# Product Change Notification

## PCN#21-1

Revision	Date	Description	Author
A	2021/1/13	A PCN for a Copied New Housing Mold for K5AT and K8	Liu, Daisy

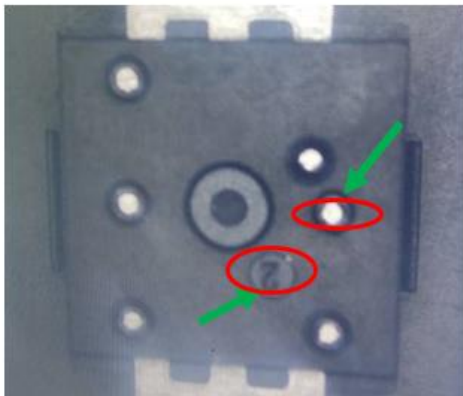
The K5AT and K8 housing mold needs to be renewed.

The new mold is a copy of the existing mold but has an extra location pin for added security and has been updated with a new cavity number in the tooling. There is a slight appearance change as a result showing the different cavity number and the new location pin, but there are no dimensional differences or change in specification, and no change to the function of the switch.

- 1) Cavity number is 1, 2, 3, 4, 5, 6, 7, 8,
- 2) Add one more location pin on the tooling

- 1) Cavity number is A, B, C, D, E, F G, H

Implementation of the new mold will be effective from Feb 15th of 2021 as the old mold can no longer be used in production..
